Proposal – KOLF

**Wiring Harness & Sub Harness Engine Integration
Proposal**

**Change : Optimize Coupler
6P → 2P**

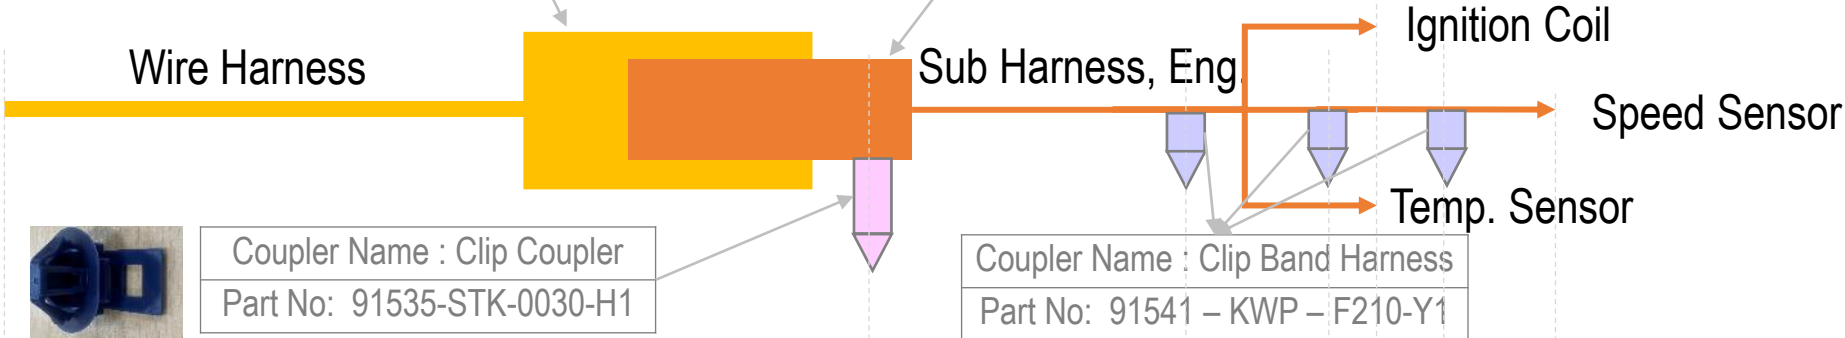
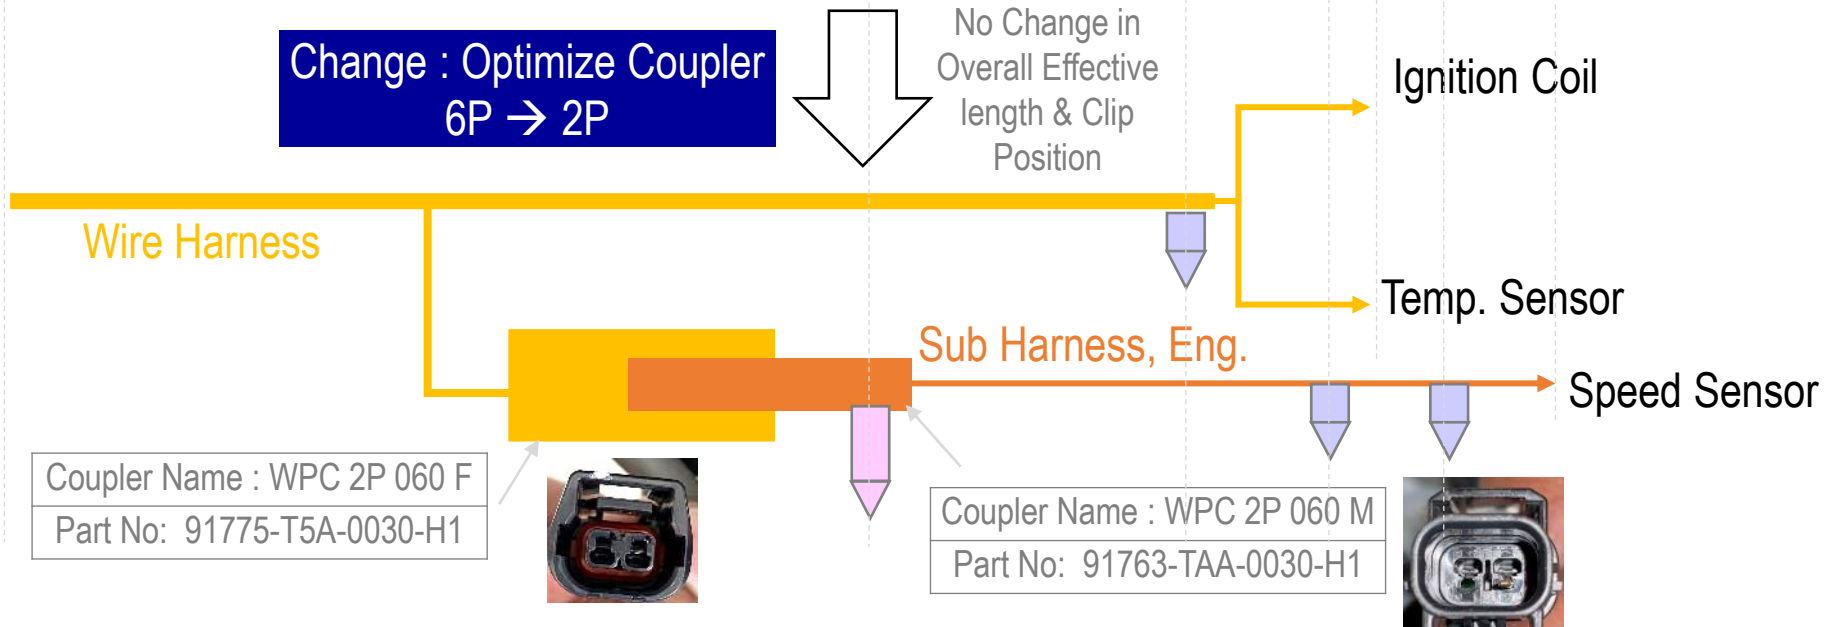
For all Digital meter models, No of circuits in Eng sub harness to be reduced from 6 ->2.
Reason : Speed Sensor has to be assembled in AE

Male Coupler			Same as K0PG
32617 MCAA710 Y1 → 91771-K0J-N010-Y1 WPC 6P 025 M → WPC 6P 025 M			
Female Coupler			
32618 MCAA710 Y1 → 91772 - KWP- H010-Y1 WPC 6P 025 F→ WPC 6P 025 F			
Condition	Harness Side	ACG Sensor Side	
Before	Female	Male	
After	Male	Female

*Change due to accommodate tapping on harness side

Waterproof Joint Sealing Process Change : Water pad to Heat shrink tube

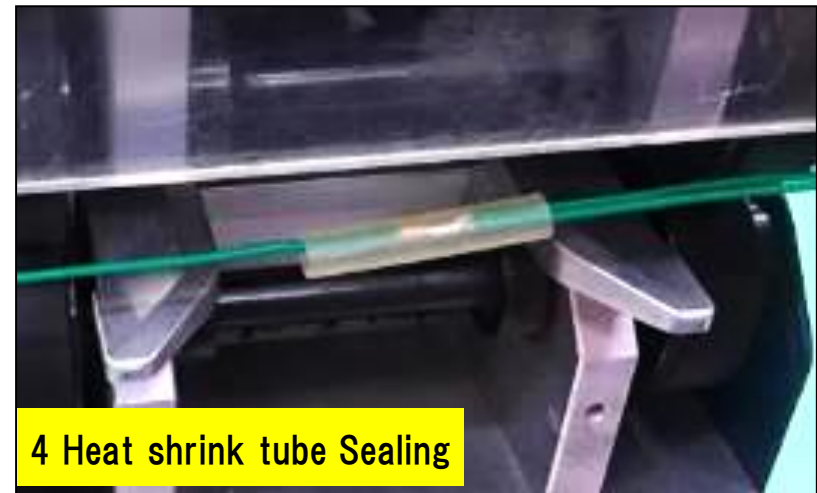
Waterproof Sealing Process: Change in Sealing (Same as KOP)

- Heat Shrink tube is already being used in Dhoot & Minda Sai Harness maker(KOP,KOY)
- Msumi is already using in KONF Model
- Now proposal for horizontal Deployment in KOLF

Waterproof joint to be change from Water pad to Heat shrink tube
